# Drainage Letter/Report

## Replat of Manley Subdivision El Paso County, Colorado

Revised: February, 2024

El Paso County Project Number: VR2310

### PROPOSED ROAD CROSS-SECTION

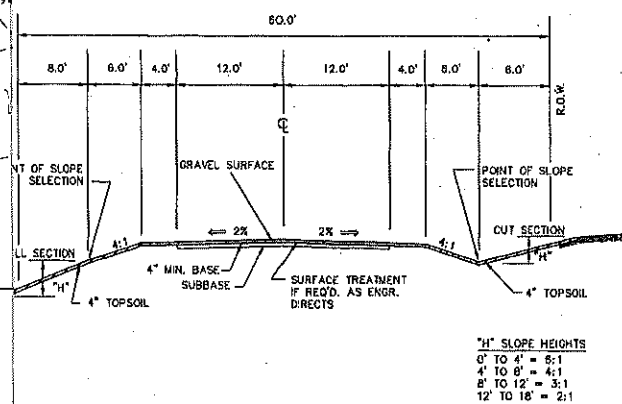
Please include entire plan sheet

Existing Plat and Proposed Replat

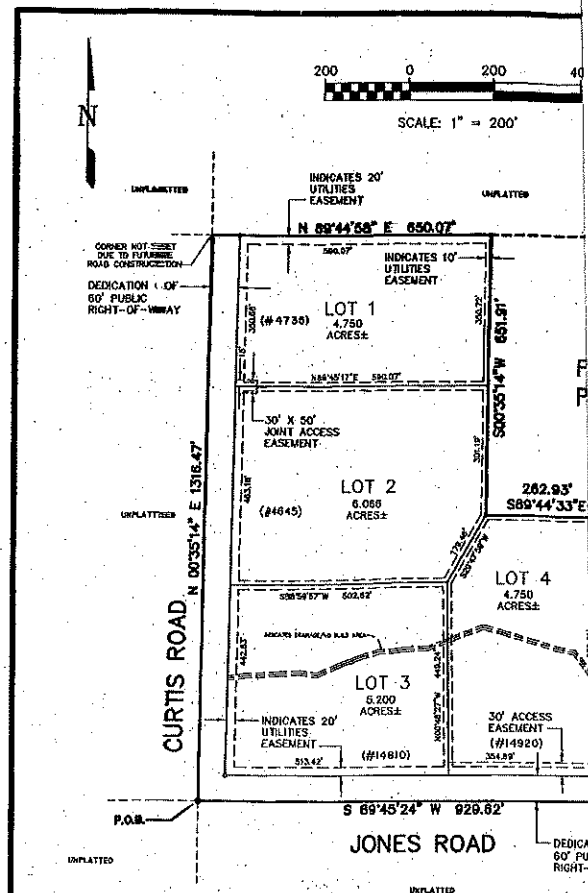
Please include entire plan sheet

**Exhibit F.2 Headwater Depth for CMP Culverts with Inlet Control**  
 (Source: Reference F.1)

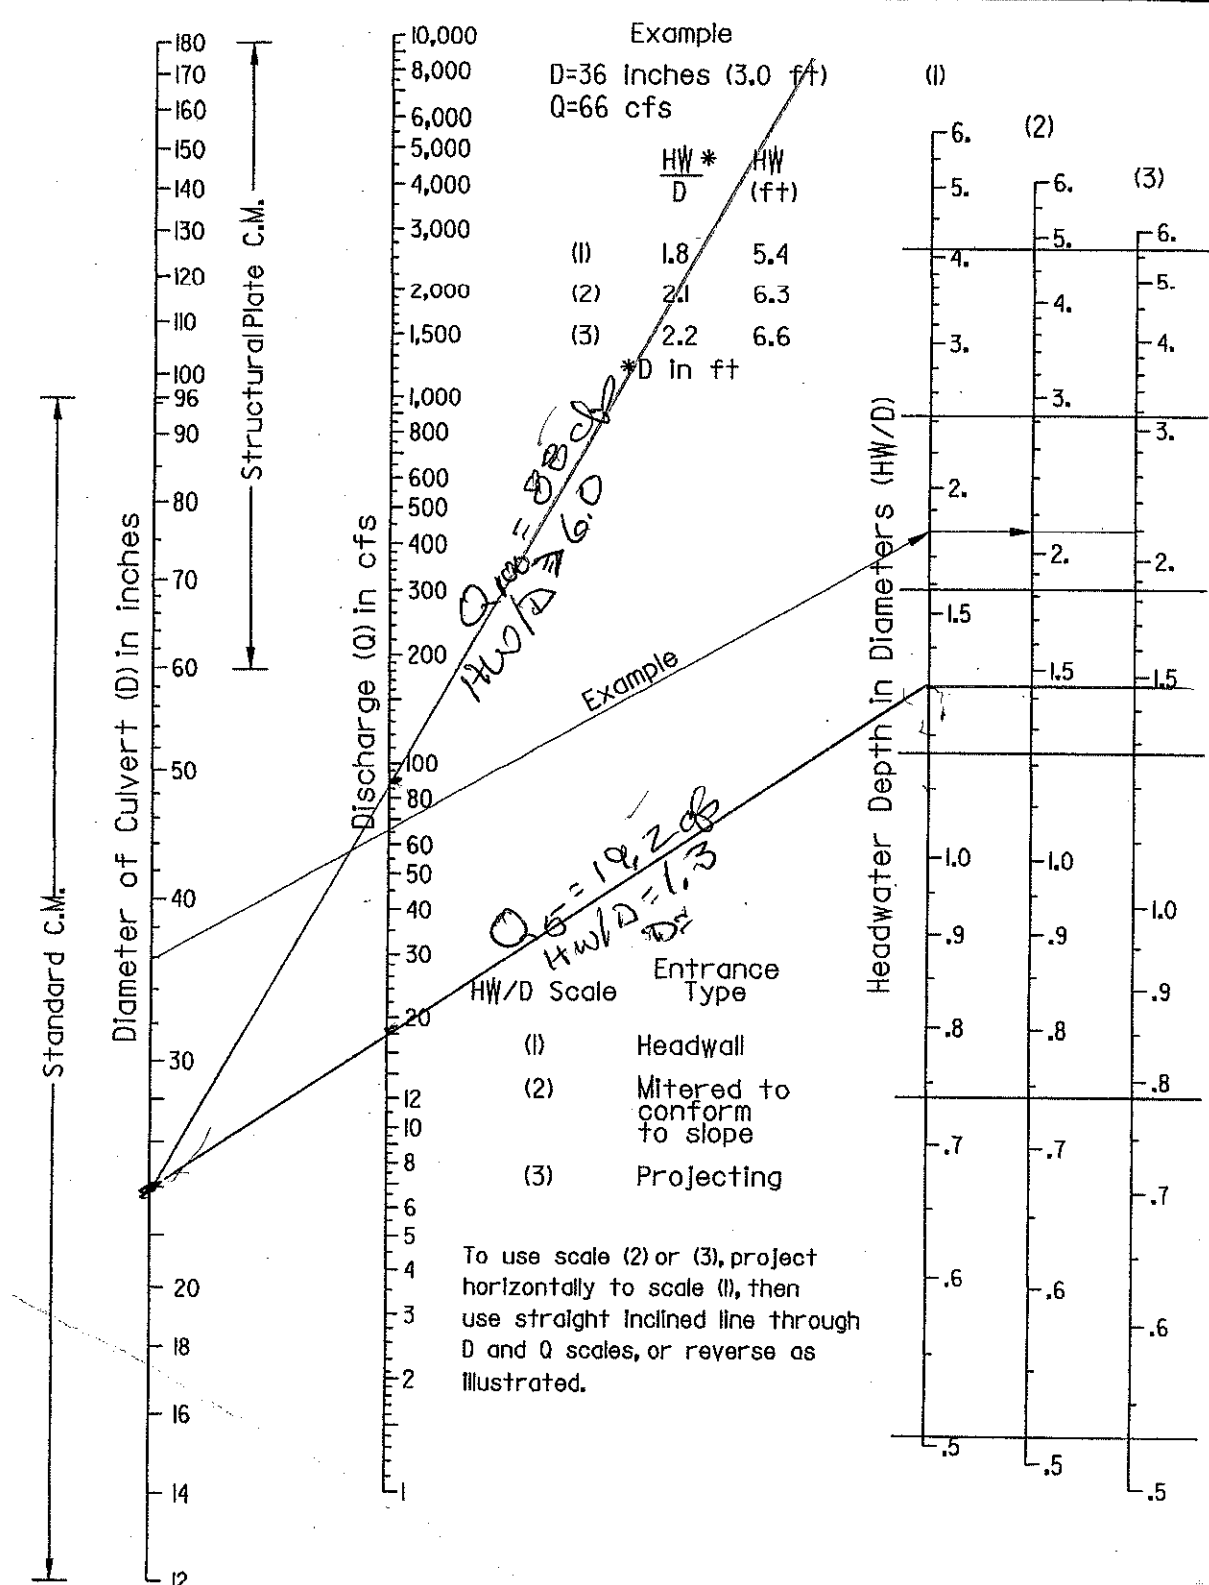
Include limits of 100-year water surface on drainage map for all 3 on site structures.
